Re: Lot 2, Woodmen Hills Filing 7J - Drainage Addendum Letter for Christian Brothers Automotive Site

This letter is an addendum to the *Final Stormwater Management and Drainage Plan for Lot 2 Woodmen Filing No. 7F*, dated July 2006, prepared by Inter-Mountain Engineering. It should be noted that Filing 7F was replatted in 2007 into two separate lots, now part of Woodmen Hills Filing No. 7J. An exhibit showing the subject property including the Filing 7F plat and Filing 7J plat is attached to this letter, refer to Appendix A. This addendum will update the above mentioned report to reflect the proposed developed condition of Lot 2 of Filing 7J, and the impacts these conditions will have on drainage patterns, quantities, existing infrastructure, and the Regional Detention and Water Quality Pond 4 (Woodmen Hills Pond No. 4).

CBAC FALCON
DRAINAGE MAP

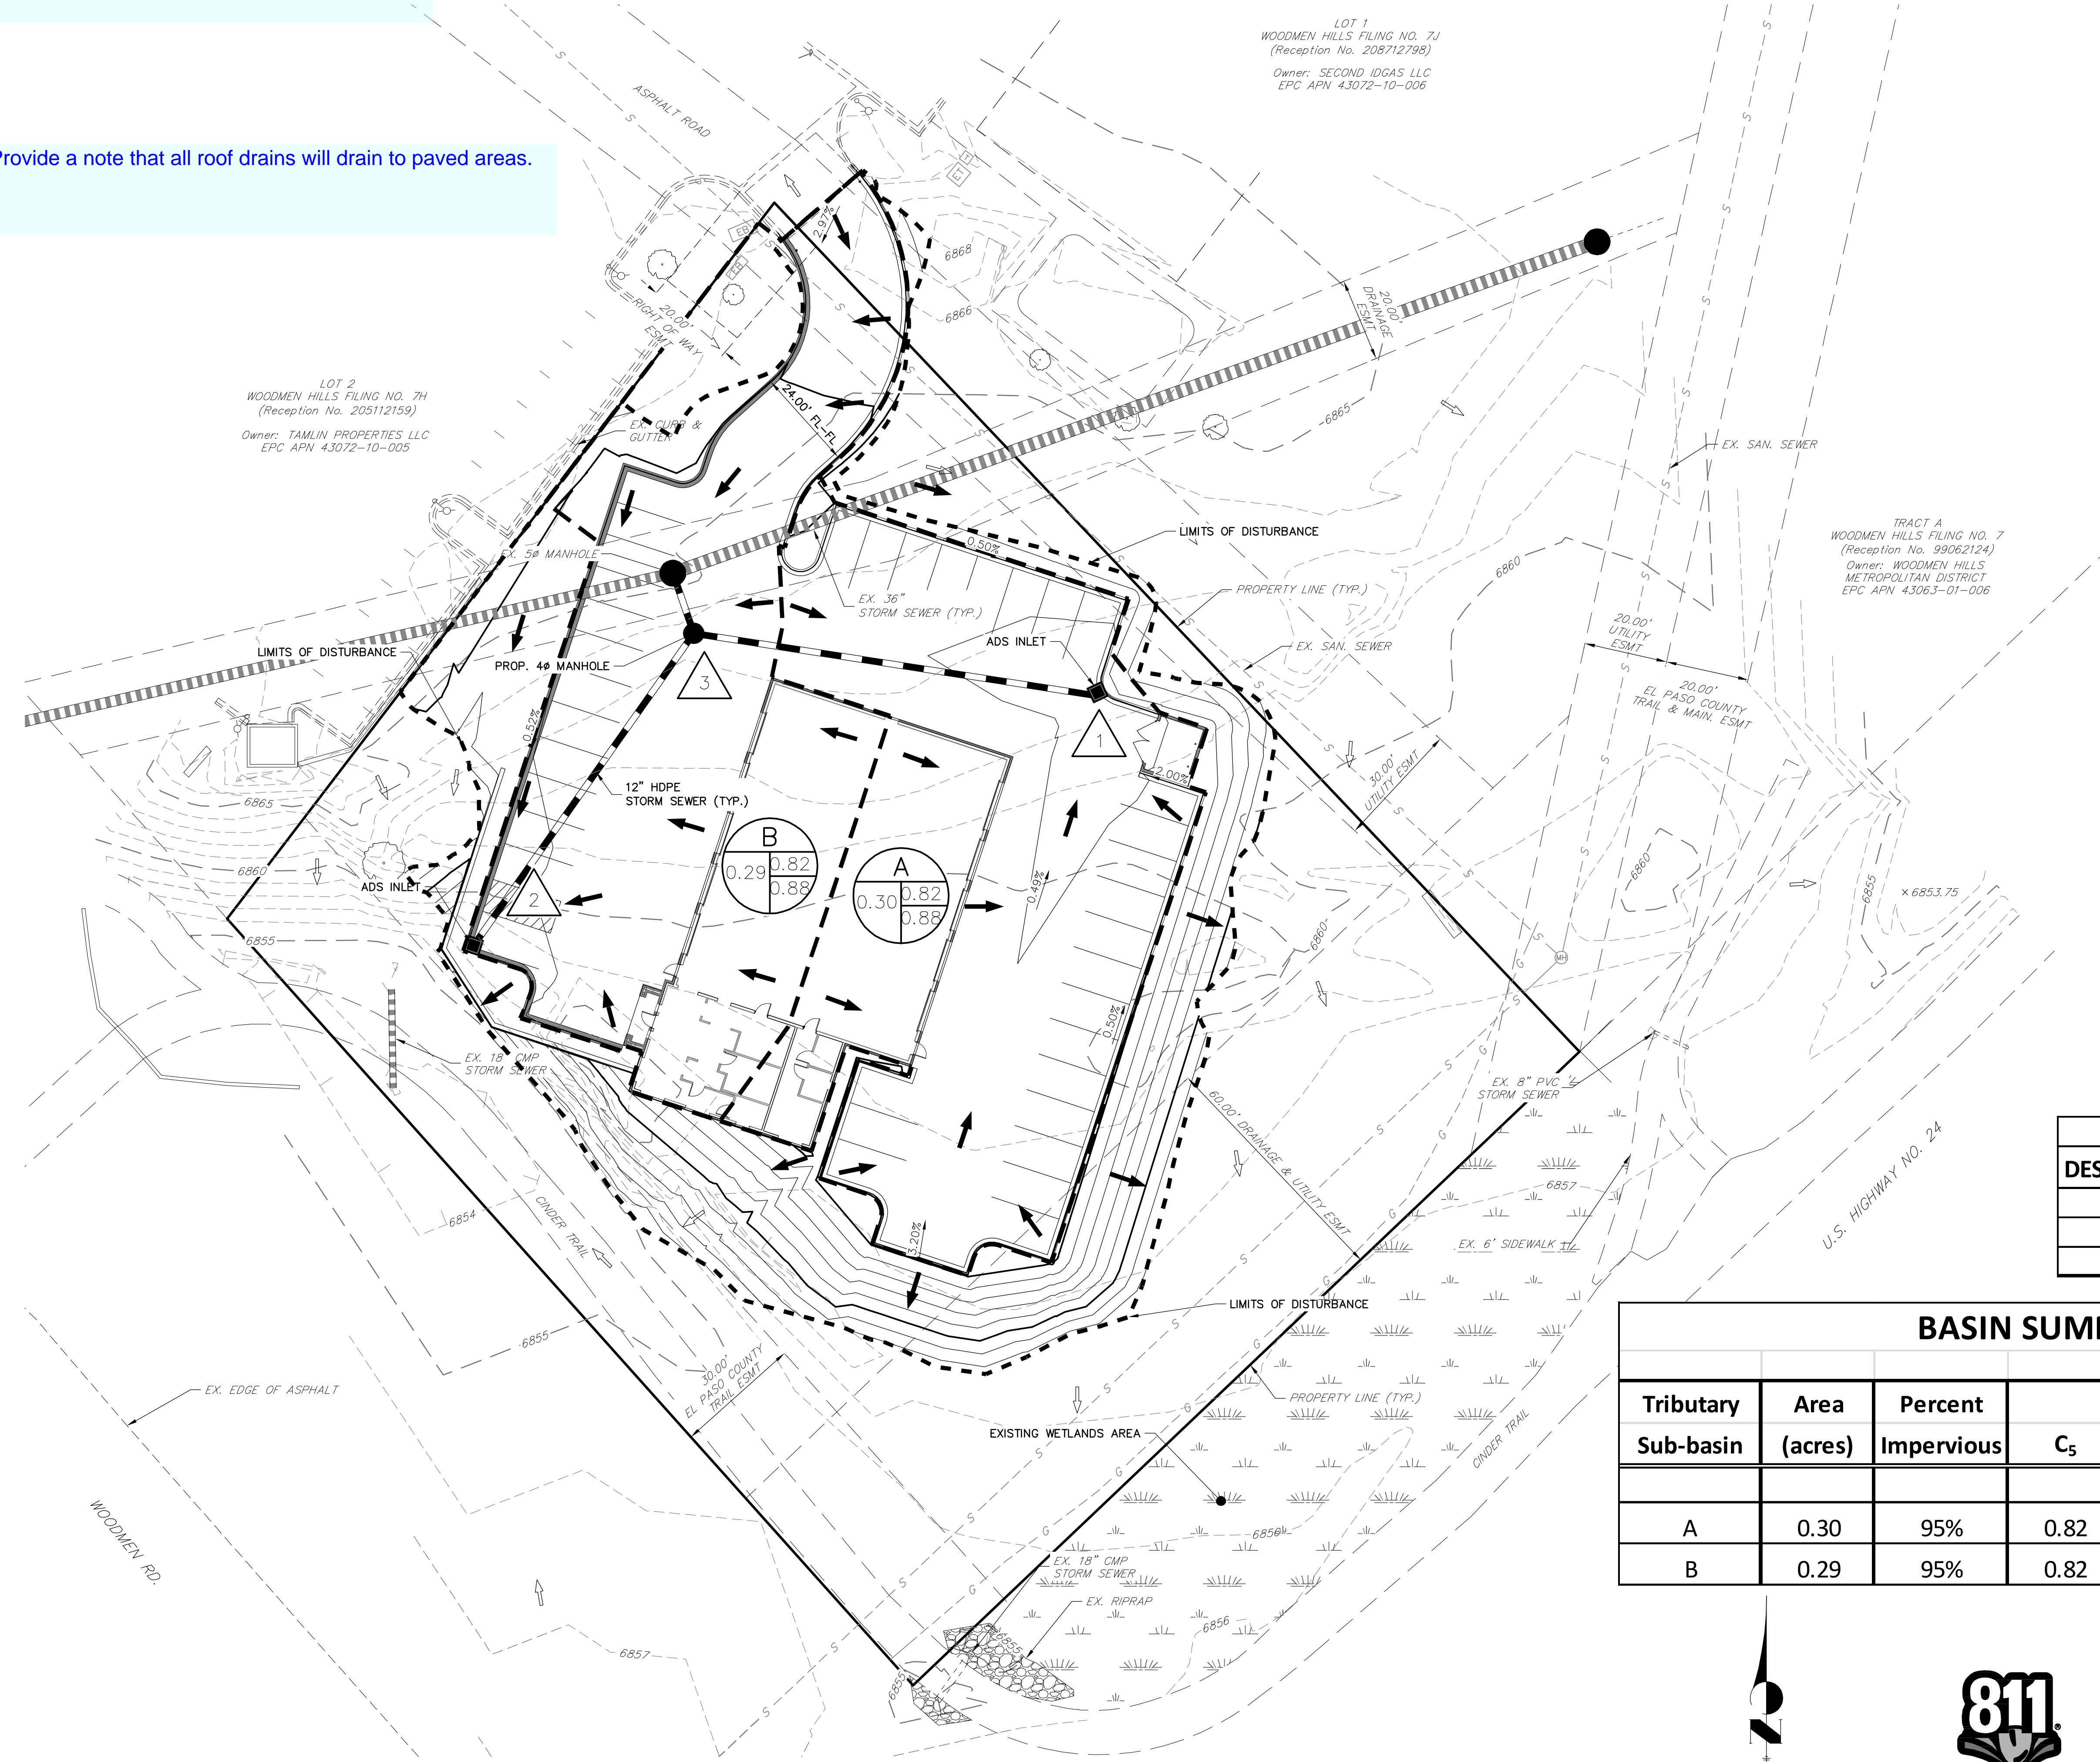
Please move this plan to the end of report.

Provide a note that all roof drains will drain to paved areas.

Provide a note that all roof drains will drain to paved areas.

Please move this plan to the end of report.
